HISTORIC AND DESIGN REVIEW COMMISSION November 06, 2019

HDRC CASE NO:	2019-596	
ADDRESS:	311 W MISTLETOE	
LEGAL DESCRIPTION:	NCB 1834 BLK 9 LOT 17 & W 4 FT OF 18	
ZONING:	R-4	
CITY COUNCIL DIST.:	1	
DISTRICT:	Monte Vista Historic District	
APPLICANT:	Tommy Richards/RICHARDS TOMMY A & SANDRA A	
OWNER:	Tommy Richards/RICHARDS TOMMY A & SANDRA A	
TYPE OF WORK:	Window replacement	
APPLICATION RECEIVED:	October 02, 2019	
60-DAY REVIEW:	December 3, 2019	
CASE MANAGER:	Rachel Rettaliata	
DEOLIDOT

The applicant is requesting a Certificate of Appropriateness for approval to replace second-story windows.

Lifestyle Series Double-Hung

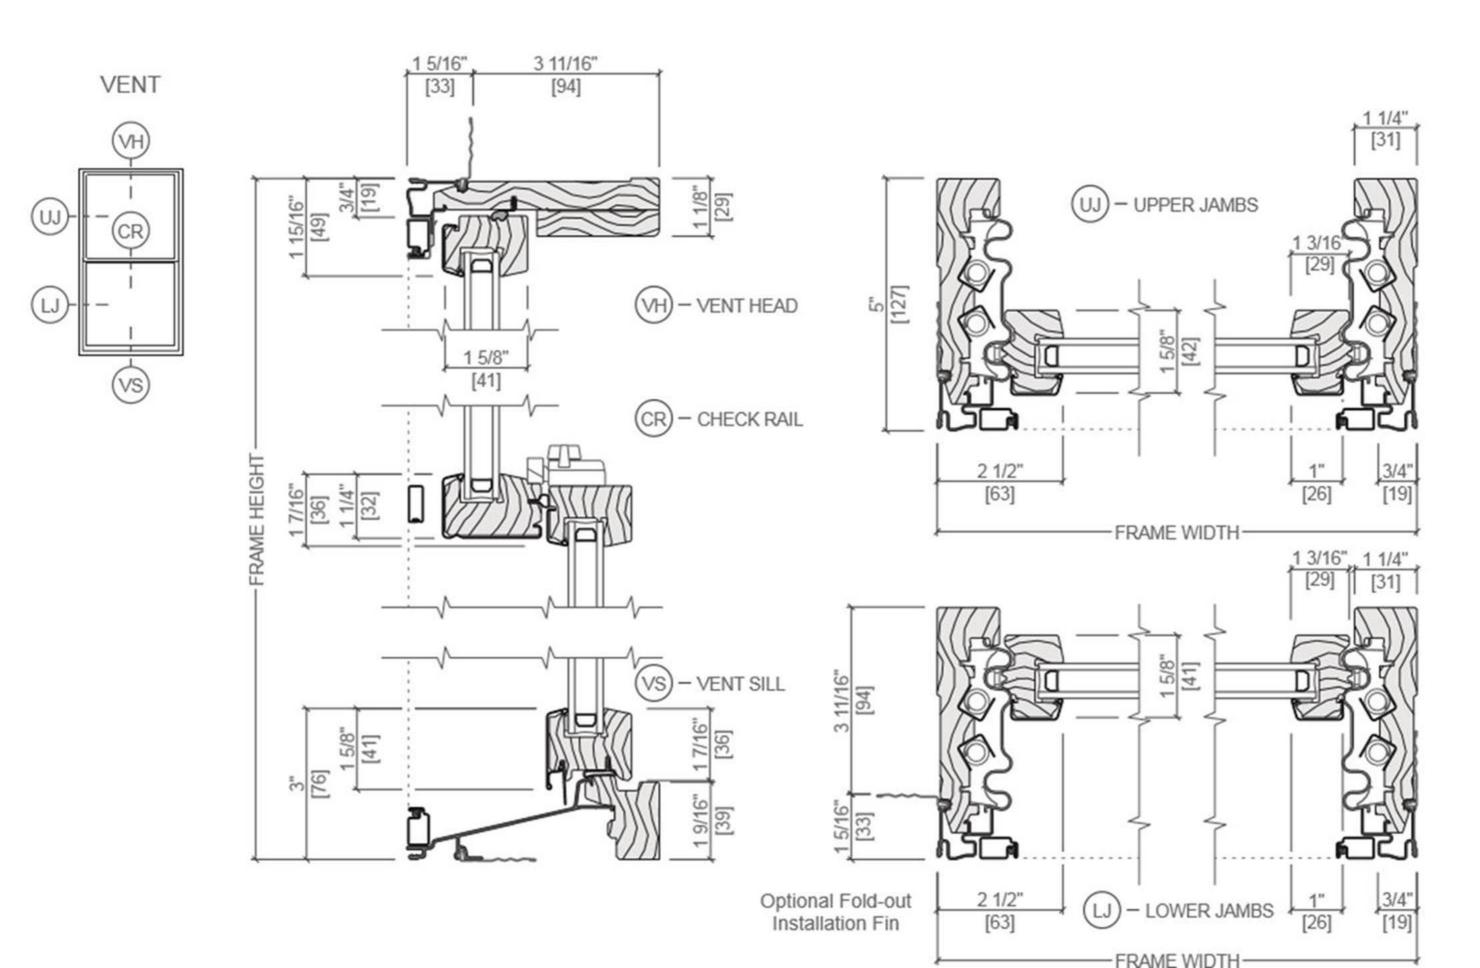
i. That the applicant installs one-over-one fully wood windows to match the existing configuration as closely as possible. The proposed aluminum clad replacement product is not appropriate. Meeting rails must be no taller than 1.25" and stiles no wider than 2.25". There should be a minimum of two inches in depth between the front face of the window trim and the front face of the top window sash. This must be accomplished by recessing the window sufficiently within the opening or with the installation of additional window trim to add thickness. The final specification should be submitted to staff for review prior to the issuance of a Certificate of Appropriateness.
